**Re: Defect Information Report – Supplemental Report No. 1
08V-668, 08C-3 (FL-542), MBE900 EPA04 High Pressure Fuel Lines**

Subject: **Safety Recall 08C3**
MBE 900 EPA04 High Pressure Fuel Lines

NUMBER: 1 1-09 **S.M. REF.:** Listed in Table **ENGINE:** EPA04 MBE 900 **DATE:** March 2009

SUBJECT: HIGH PRESSURE FUEL LINES AND TRANSFER TUBES

Figure 1 High Pressure Fuel Line

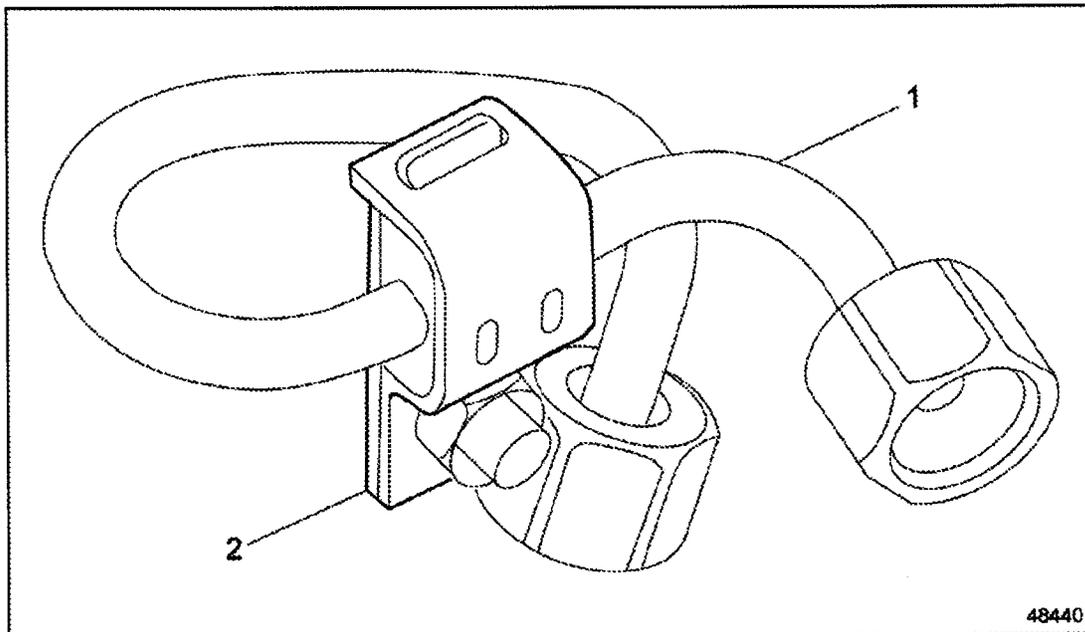
2. Remove the engine lifting bracket to improve access to the fuel lines.
 - [a] Remove the left front lifting bracket by removing the three bolts securing the bracket to the cylinder head.
 - [b] If the application has a high mount fan, remove the three secondary mount bracket retention bolts on the cylinder head and the two bolts on the high mount fan bracket.
3. To prevent the transfer tube from rotating during the high pressure fuel line disassembly, secure the transfer tube thrust nut using a 24 mm fuel line wrench (J-47484 or J-45063) and loosen the high pressure fuel line nut at the transfer tube using a 17 mm fuel line wrench (J-47483) or a 17 mm open end wrench. See Figure 1.

4. Using a 17 mm fuel line wrench (J-47483) or a 17 mm open end wrench, loosen the high pressure fuel injector line nut at the electronic unit pump. Discard the high pressure fuel injector line.
 5. Using a 24 mm fuel line wrench (J-45063 or J-47484) or a 24 mm socket, loosen the thrust nut on the transfer tube. Remove and discard the transfer tube and the O-ring. See Figure 1.
-

Figure 2 Damper Clamp Alignment

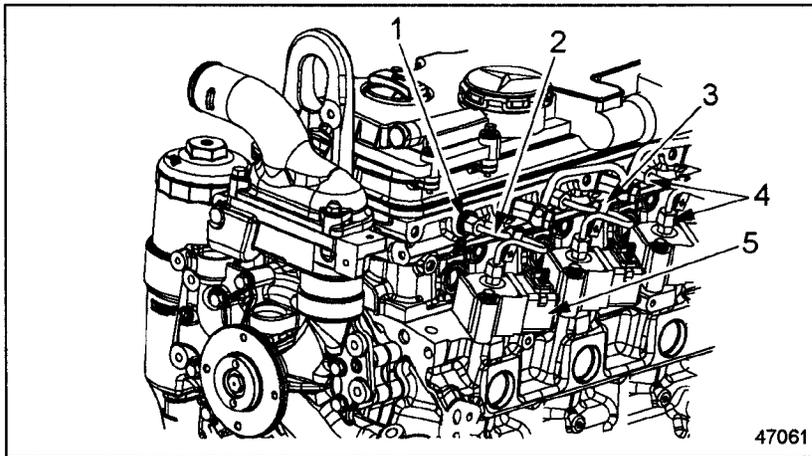
1. The new high pressure fuel line comes assembled with the damper clamp. Ensure that the damper clamp is aligned correctly on the high pressure fuel line and is not in contact with surrounding engine components. See Figure 2.

Figure 3 High Pressure Fuel Line

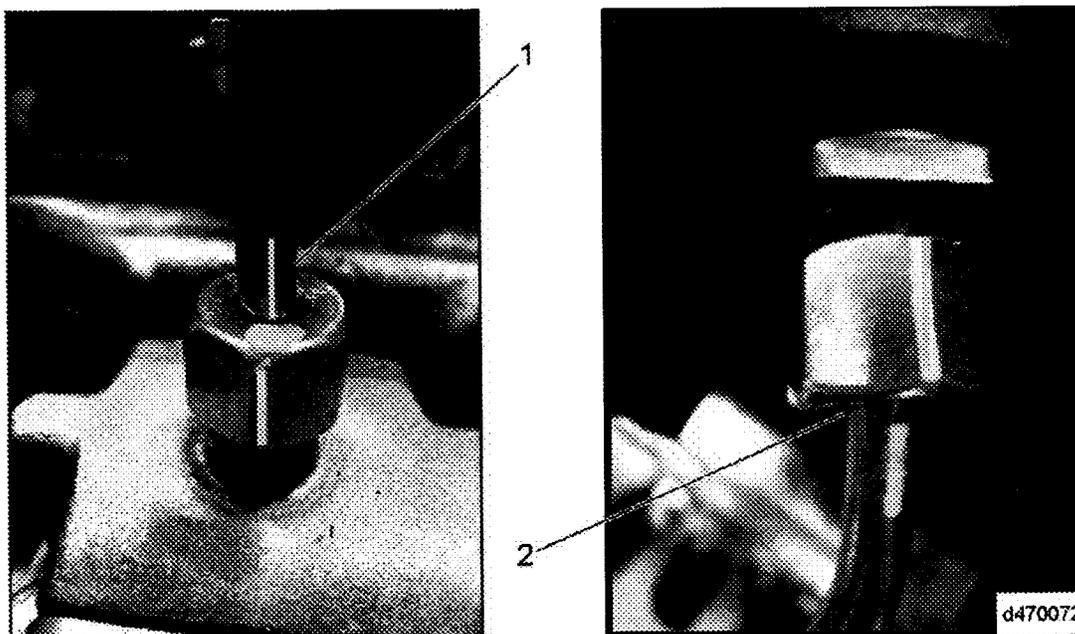
5. Hand-tighten the high pressure fuel injector line nut first at the unit pump, and then at the transfer tube. While hand tightening the nuts, gently move the high pressure fuel line back and forth to ensure the end of the line is properly seated in the transfer tube and unit pump fitting. If the high pressure fuel injector line has been installed incorrectly and torqued, remove the high pressure fuel injector line and transfer tube and replace with new parts. Ensure that the damper clamp is not touching any other fuel lines or other engine or vehicle components. See Figure 3.

Figure 4 Marking of High Pressure Fuel Injector Line and Nuts

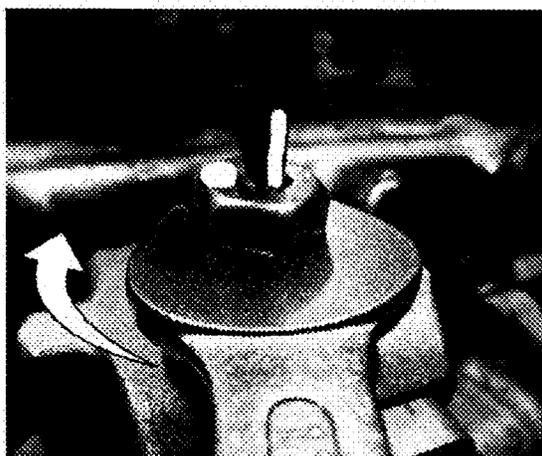
6. Once the high pressure fuel injector line nuts are hand tight, draw a vertical line with a highly visible marker along the front edge of both of the nuts and up the fuel line. The line drawn along the edge of the nuts and the fuel line should be aligned. See Figure 4.
